Babcock & Wilcox

Commercial Nuclear Fuel Plant

The Babcock & Wilcox Company, Commercial Nuclear Fuel Plant submits the following responses to your questions on our Environmental Report.

Environmental Impact Assessment

ATTACHMENT 3

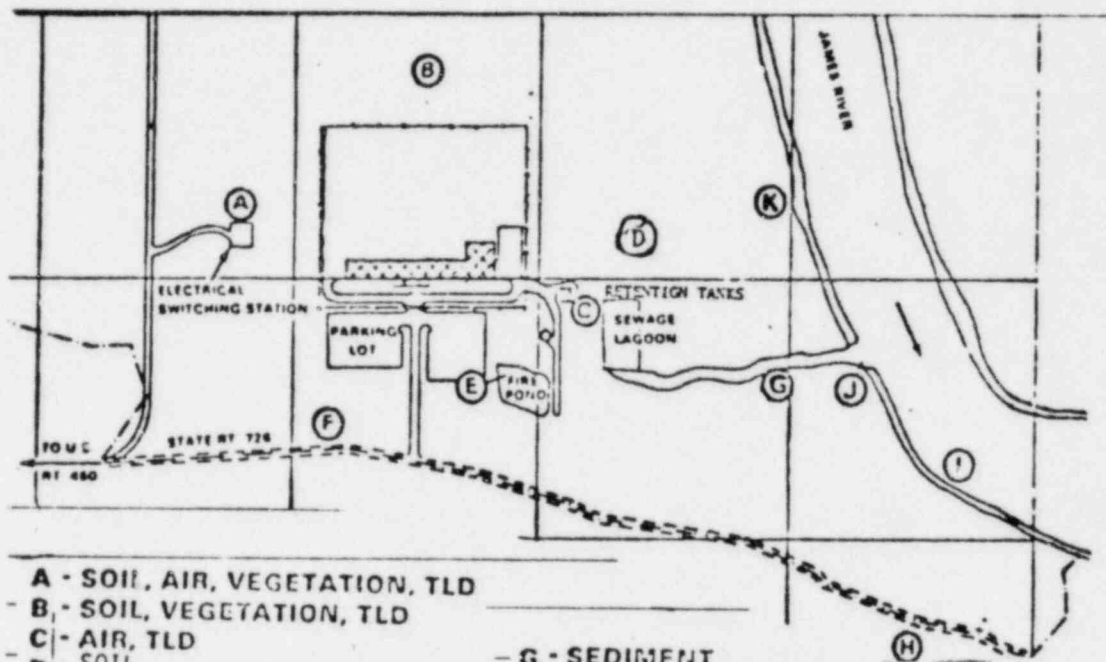
7. Our current environmental program is summarized in Attachment 3 to this letter. Attachment 4 to this letter is a five year summary of our environmental data.
